ADDENDUM TO FINAL

**SEAWEST/KENETECH WINDFARM
DEVELOPMENT COMPARISON,
CARBON COUNTY, WYOMING**

Bureau of Land Management
Rawlins, Wyoming

TRC Mariah Associates Inc.
Laramie, Wyoming

Map 2.1 Site Plan, MHI MWT-450 600-kW Turbine.

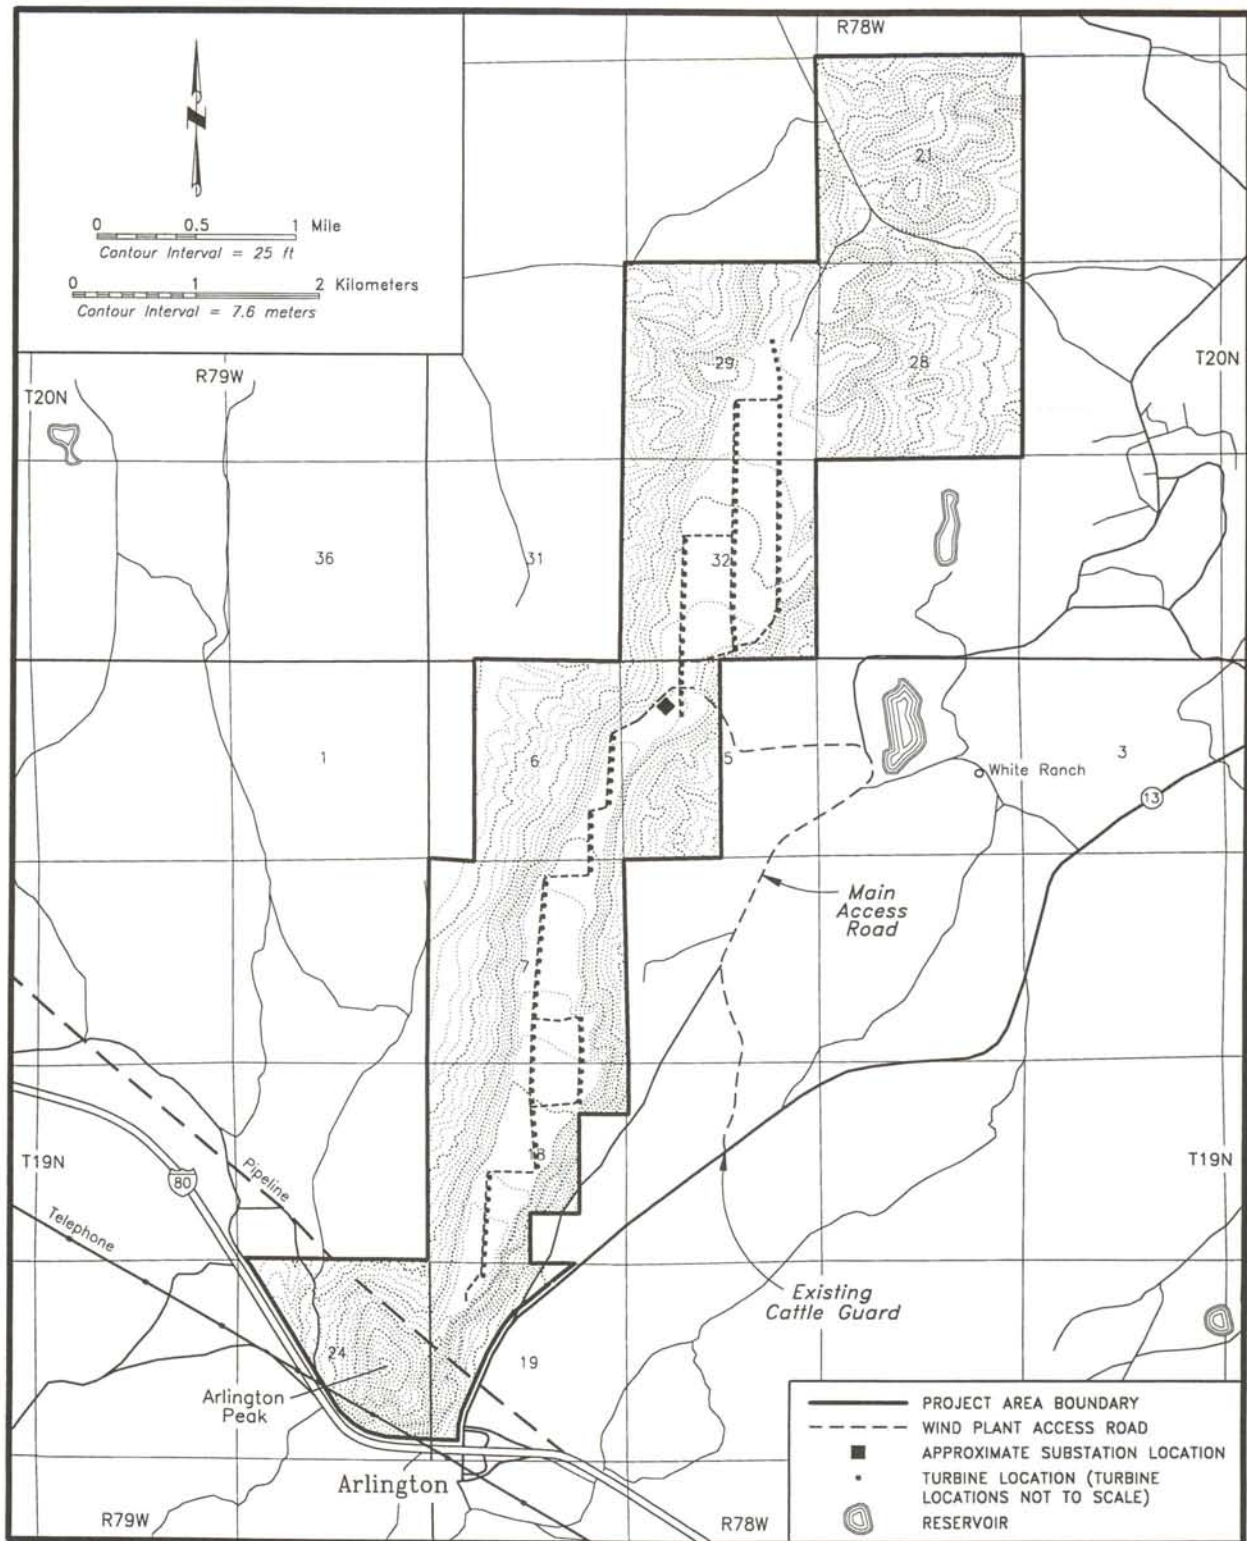
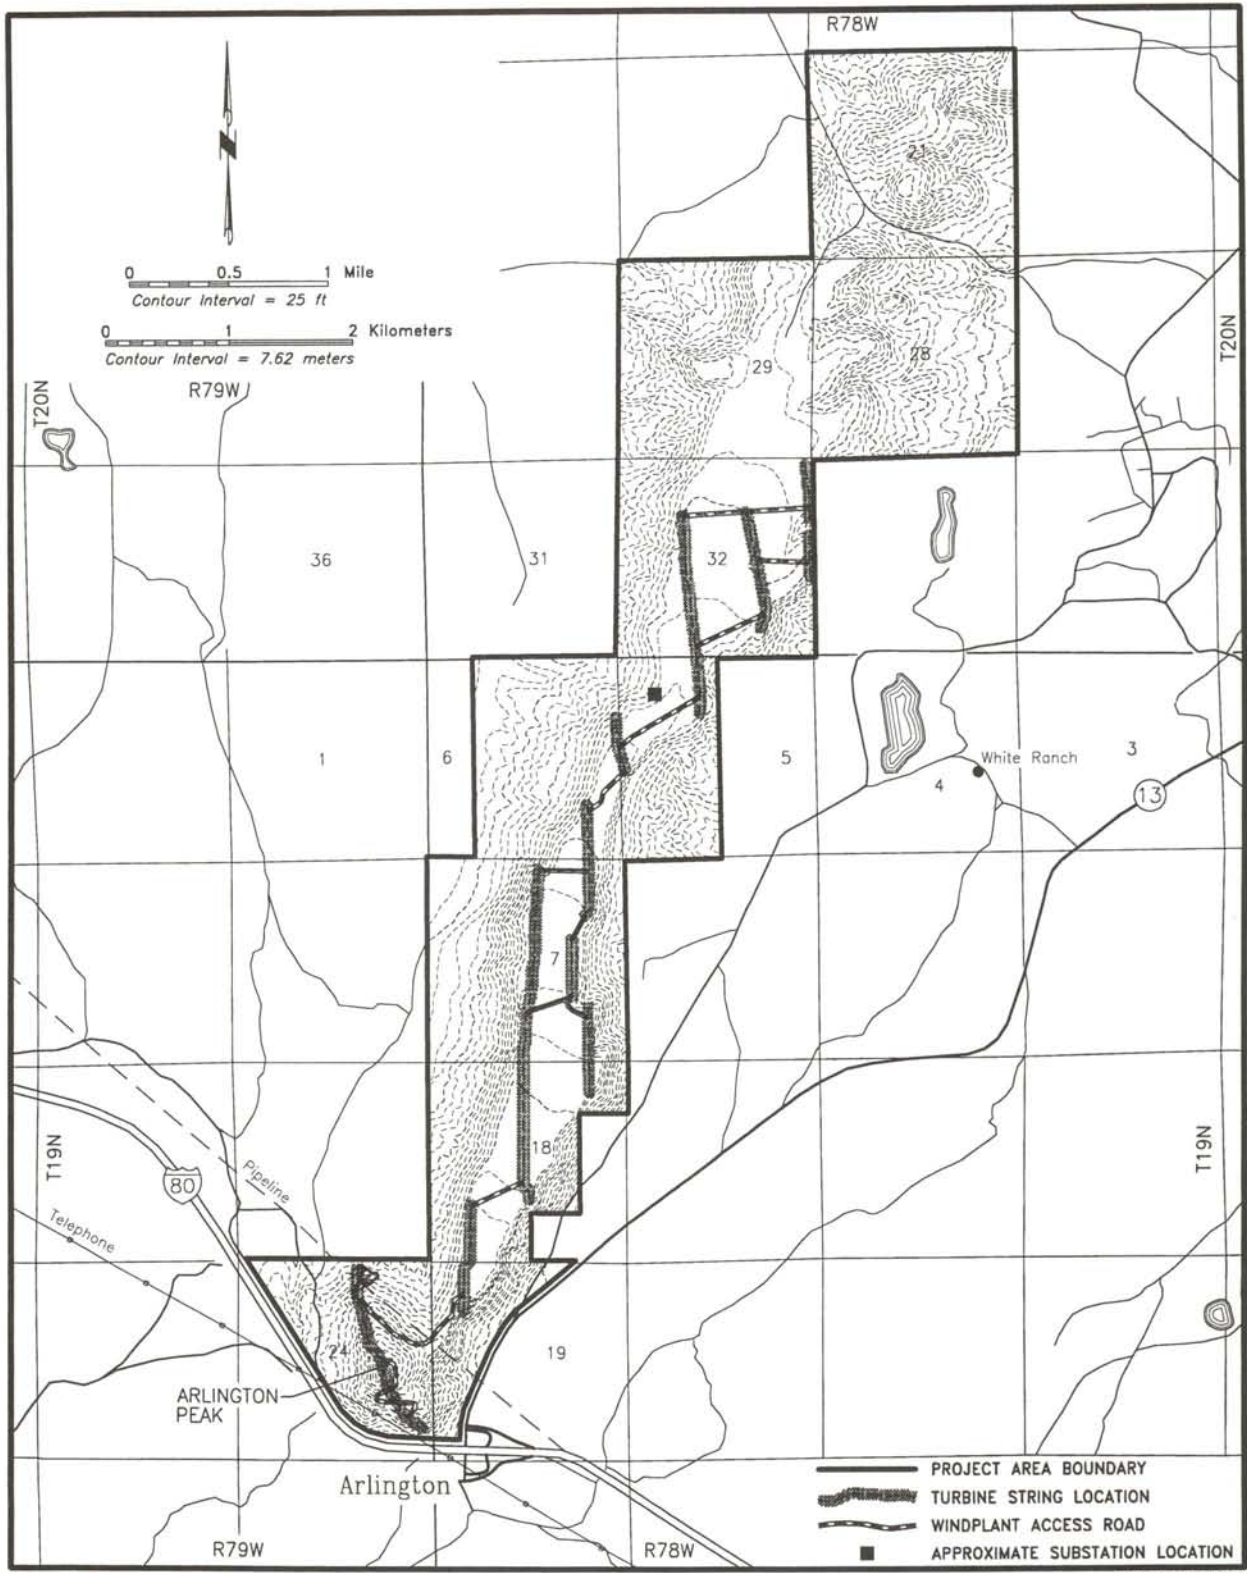
Entire text: SeaWest will purchase MHI MWT-450 600-kW wind turbines for Phase I from MHI. Turbine specifications are presented in Table 2.3. The final site plan is governed, in part, by the maximum output of the MHI MWT-450 600-kW wind turbine and by the build-out of Phase I to 133 wind turbines. Map 2.1 has been amended to show the site plan using the MHI MWT-450 600-kW wind turbine. Map 2.2 (750-kW wind turbine siting) has been deleted. Map 2.3 shows the site plan for KENETECH's proposed Phase I development using the KVS-33 400-kW turbine.

Paragraph 2: At Foote Creek Rim, Phase I wind turbines would be placed along the rim in eight turbine strings (Map 2.1), whereas KENETECH had proposed 12 Phase I strings (BLM 1995c). String length would vary from 2,030 to 7,800 ft (619 to 2,379 m) as compared with string lengths of 1,584 to 10,560 ft (483 to 3,219 m) under the KENETECH proposal.
